RE: Proposed License Amendments to Turkey Point Plant, Units 3 and 4 -
Update of Offsite Organization

EVALUATION OF PROPOSED CHANGES TO TURKEY POINT

TECHNICAL SPECIFICATIONS

FIGURE 6.2-1 OFFSITE ORGANIZATION FOR FACILITY MANAGEMENT AND TECHNICAL SUPPORT

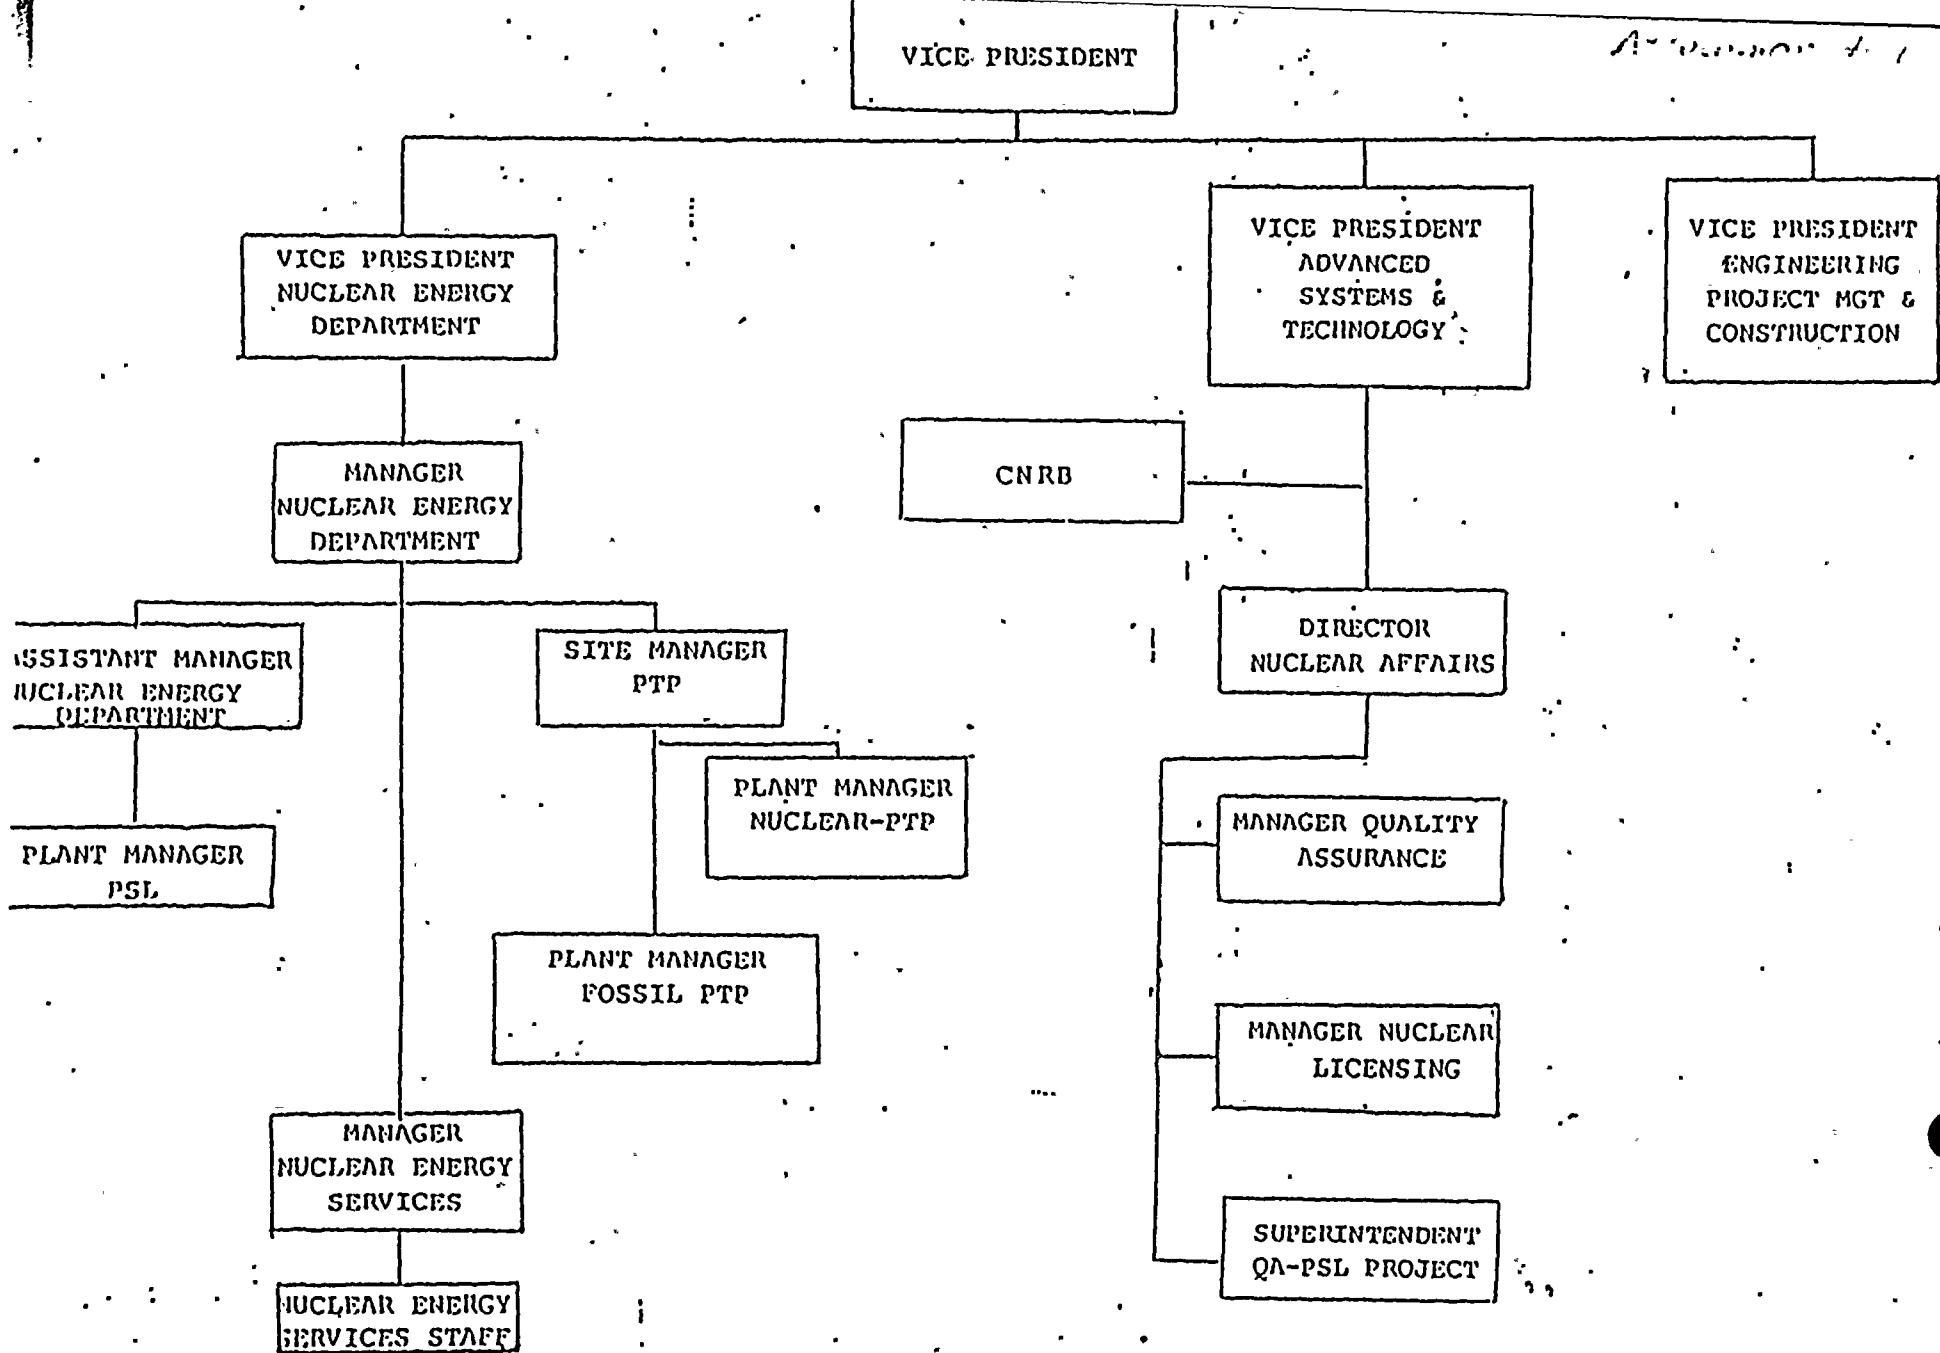
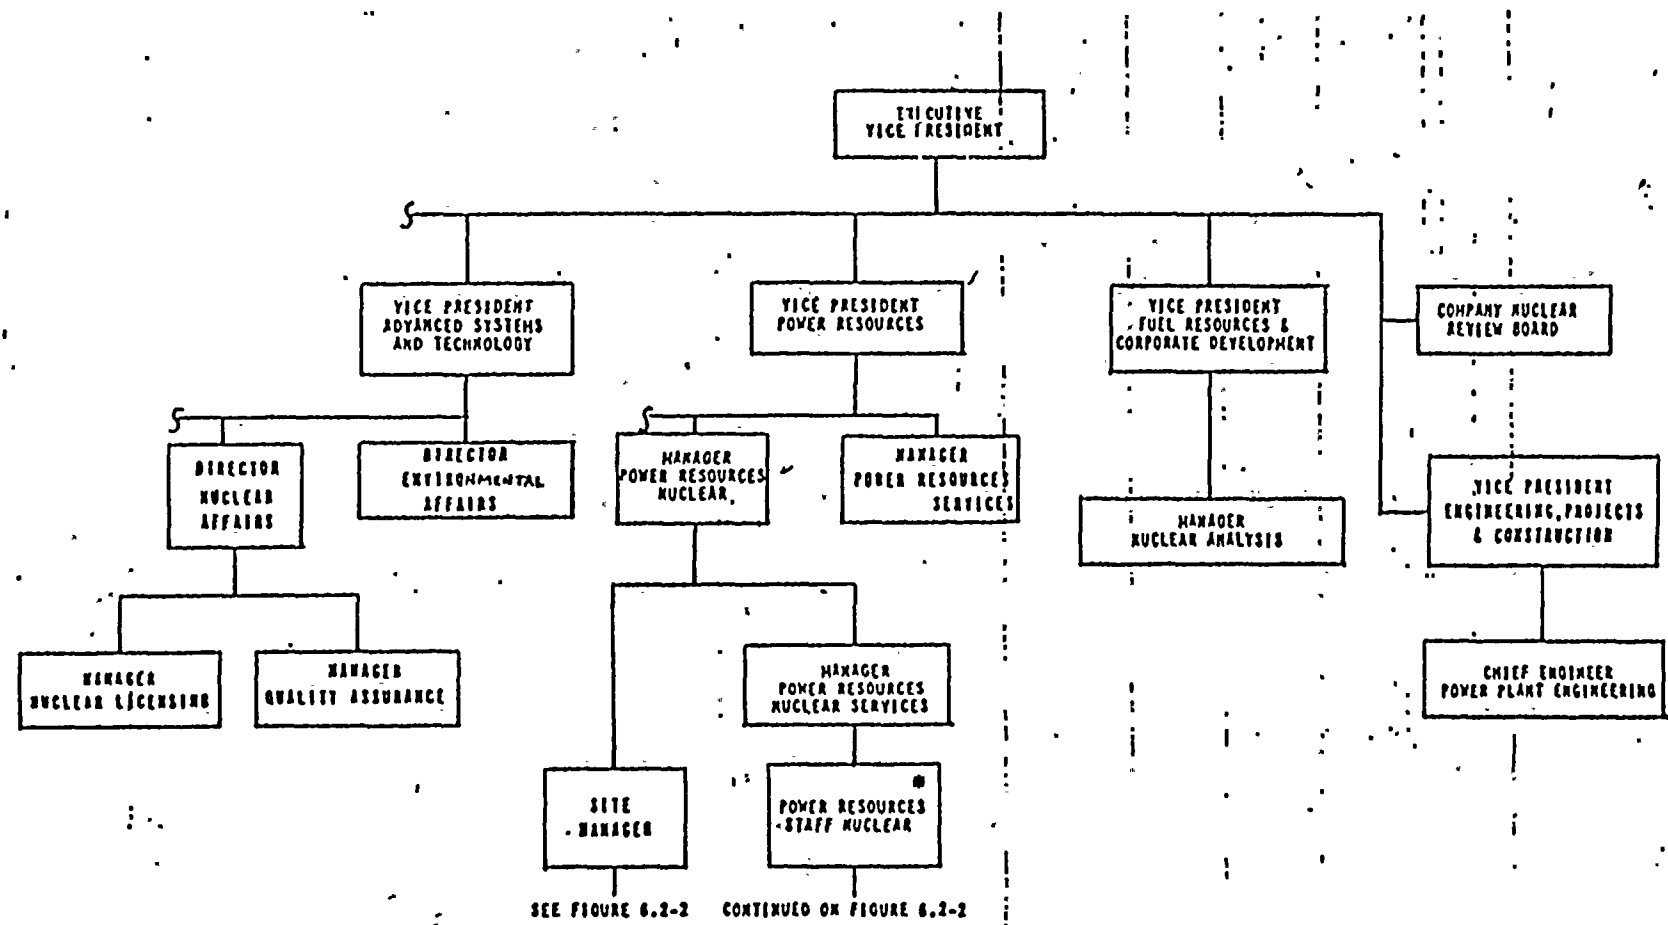
The licensee proposes to modify Figure 6.2-1, "Offsite Organization for Facility Management and Technical Support" to show that a Nuclear Energy Department (NED) has been formed to manage the nuclear activities that were previously managed by the Power Resources Department. The new NED is headed by a Vice President who reports directly to the FPL Executive Vice President. Reporting to the new Vice President-NED is a Manager-NED, a position that was previously titled Manager-Power Resources-Nuclear and that previously reported to the Vice President-Power Resources. The Site Manager and the Manager-Nuclear Engineering Services (title changed from Manager-Power Resources Nuclear Services) and a new position titled Assistant Manager NED report to the Manager-NED. Proposed new Figure 6.2-1 and current Figure 6.2-1, respectively, are shown in Attachments 1 and 2.

We conclude that the organization structure changes as discussed above should not diminish FPL's ability to safely operate the Turkey Point Units 3 & 4 and the proposed modifications to Figures 6.2-1 and 6.2-2 to reflect these changes are acceptable.
